CALL NO. 102
CONTRACT ID NO. 121001
ADDENDUM # 2

Subject: Pike County, APD 0806 (040)
Letting January 27, 2012

- (1) Revised - Plan Sheets - T1, T56, T57, & T58
- (2) Revised - Bid Items - Pages 84-88 of 88

* Total Area includes Exit Number Signs that are not shown.

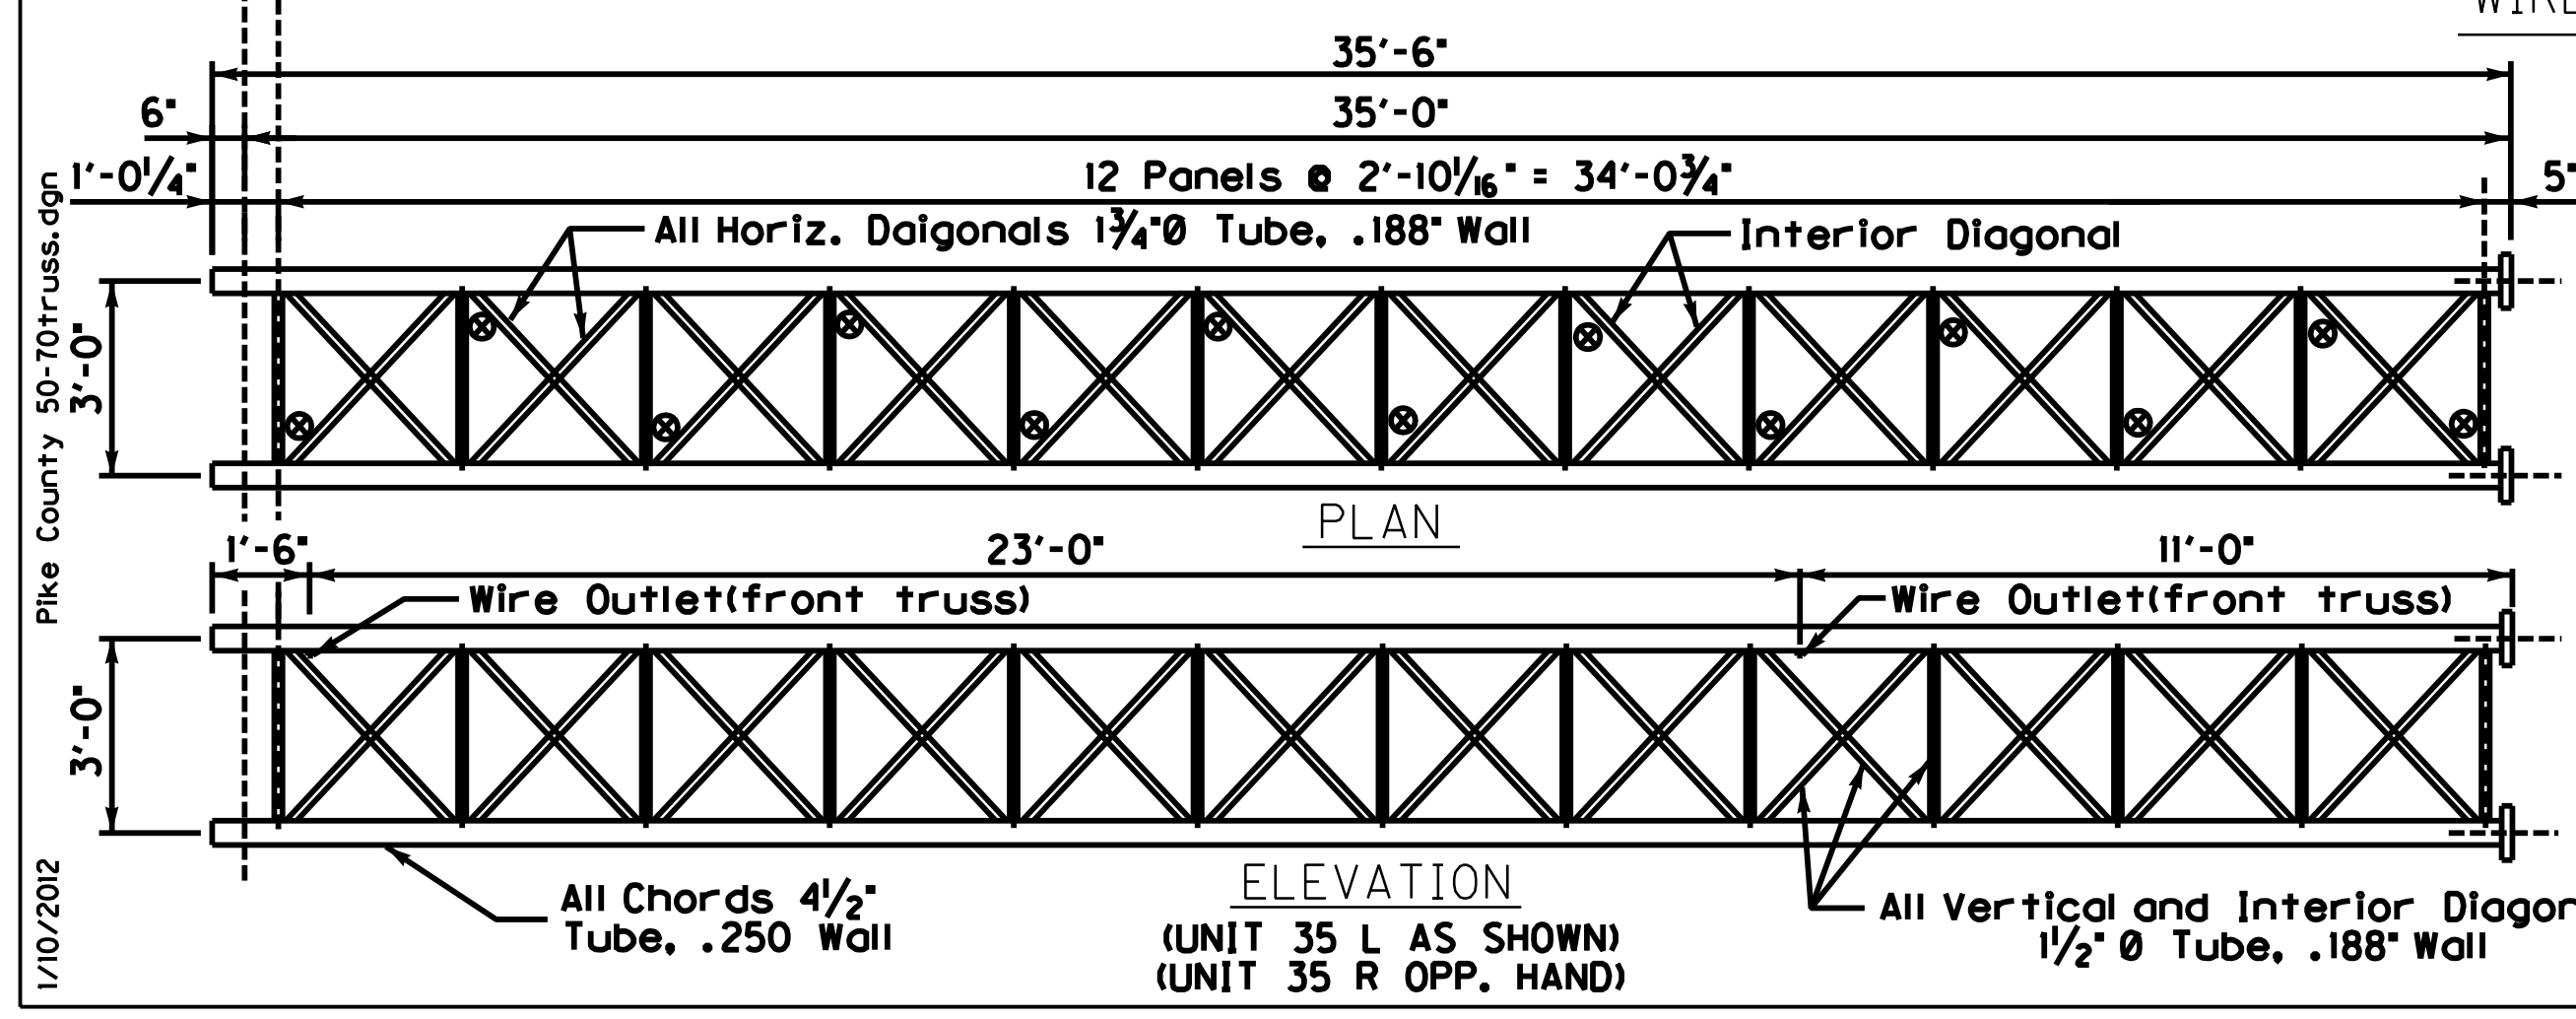
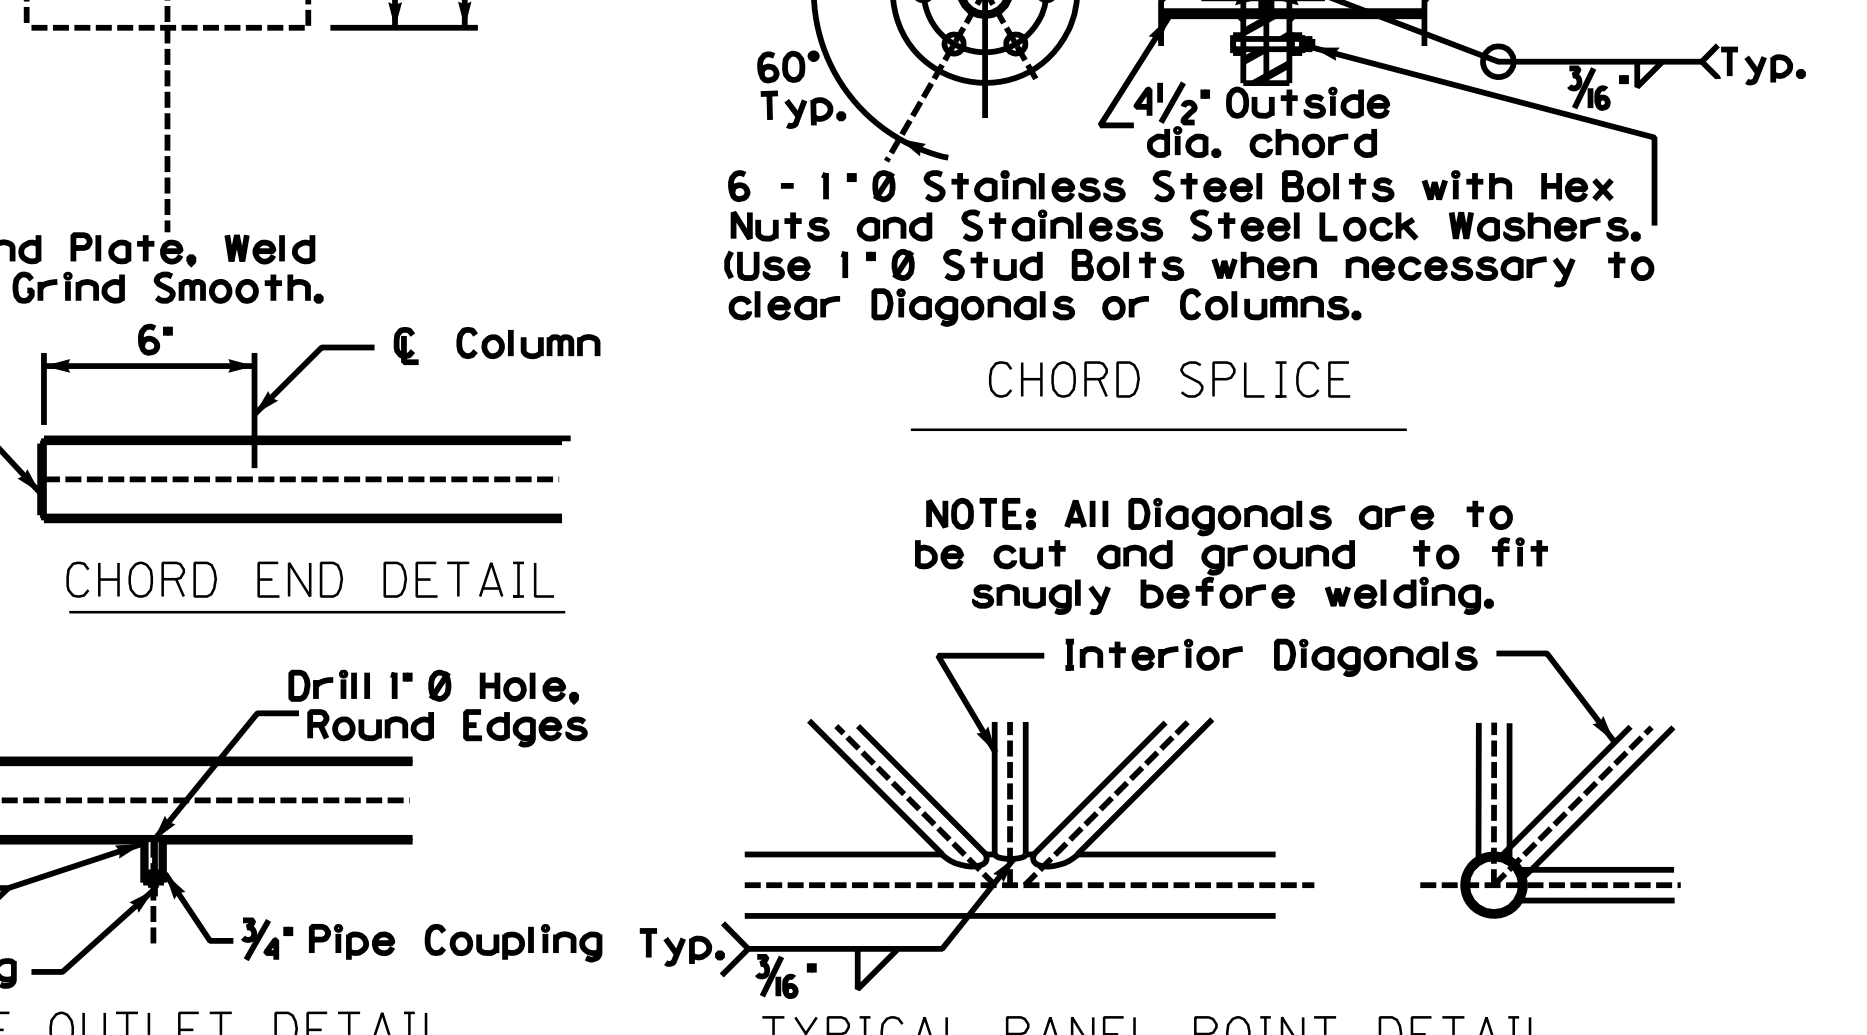
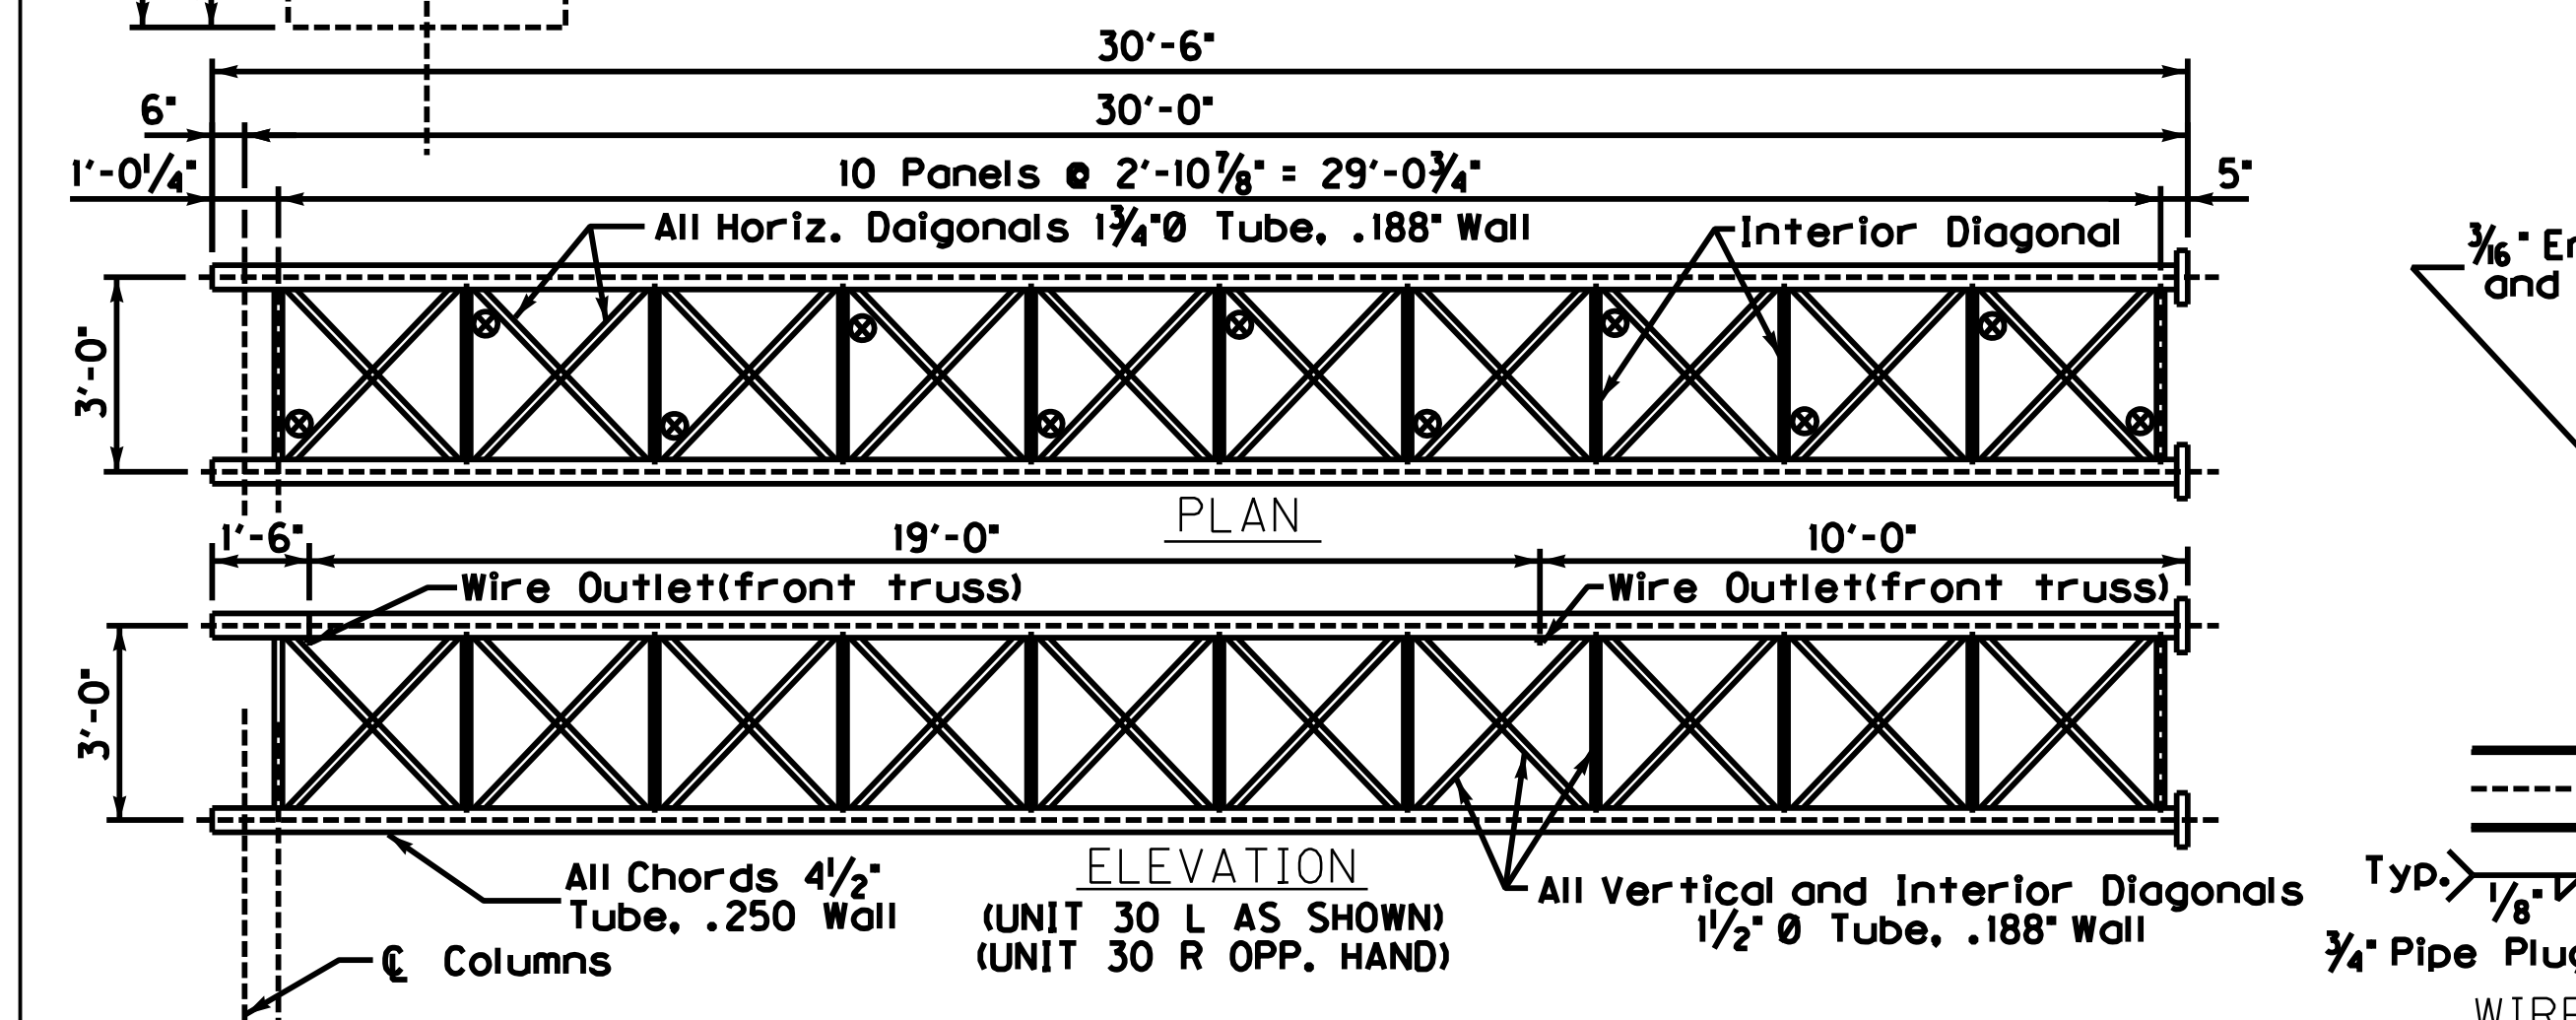
STA. 1+160
 NOTE: SIGN TRUSS FOUNDATION DATA (UP TO BASE PLATE) FOR INFORMATION ONLY. SUPERSTRUCTURE TO BE CONSTRUCTED UNDER THIS PROJECT.
